SUNDRY NOTICES AND REPORTS ON WELLS
Do not use this form for proposals to drill or to re-enter an abandoned well. Use form 3160-3 (APD) for such proposals.

8. Well Name and No.
RUBY FEDERAL 33

9. API Well No.
30-025-41505-00-X1

ConocoPhillips Company respectfully requests a change to our original APD for this well. COPC proposes to perform a remedial cement operation to achieve cement to surface. The need for additional work has been communicated to BLM staff members Jennifer Mason and Ed Fernandez via telephone and email.

CONOCO PHILLIPS RUBY FEDERAL 33

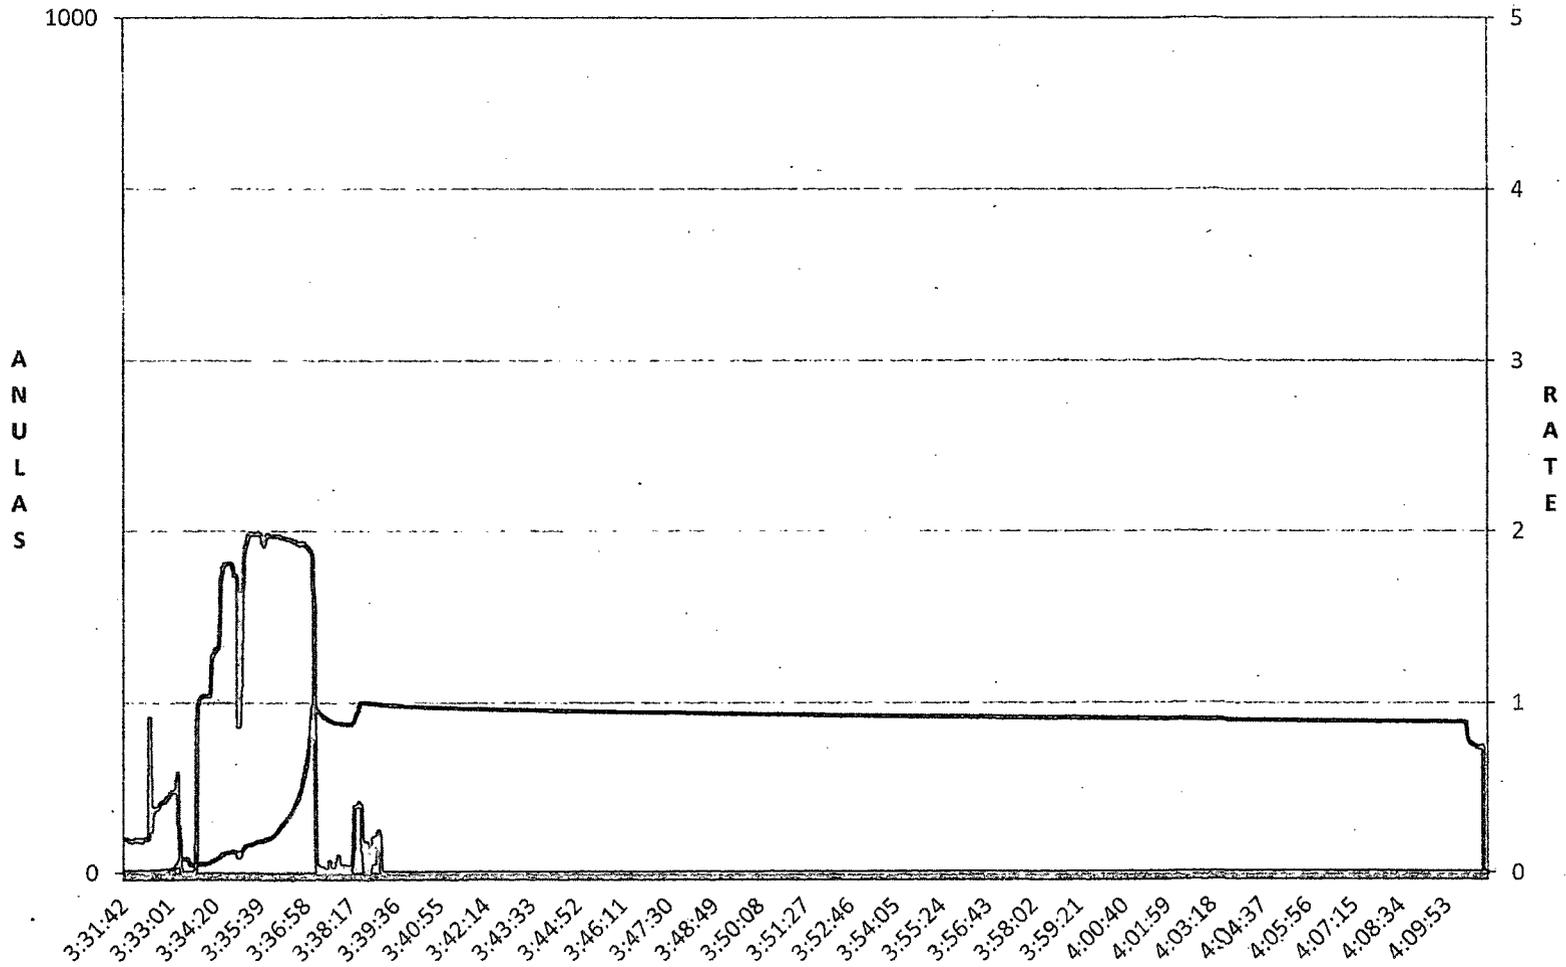
Engineering decided to utilize the Formation Integrity Test results as a basis for satisfying the BLM request to conduct a pressure test, because of the open hole zone. On Thursday, February 20, 2014 we pressure tested the 8-5/8" by 5-1/2" casing annulus with PetroPlex. Prior to pressure test, the annular pressure gauge read 0 psi. We pressured up to 200 psi on the surface by production casing annulus and at 2:38 pm NM time, we began the test and monitored annulus pressure for 30 minutes. The test was concluded and the 8-5/8" by 5-1/2" casing annulus pressure was recorded at 179 psi.

START TIME/PSI 2:38 200PSI
END TIME/PSI 3:08 179 PSI
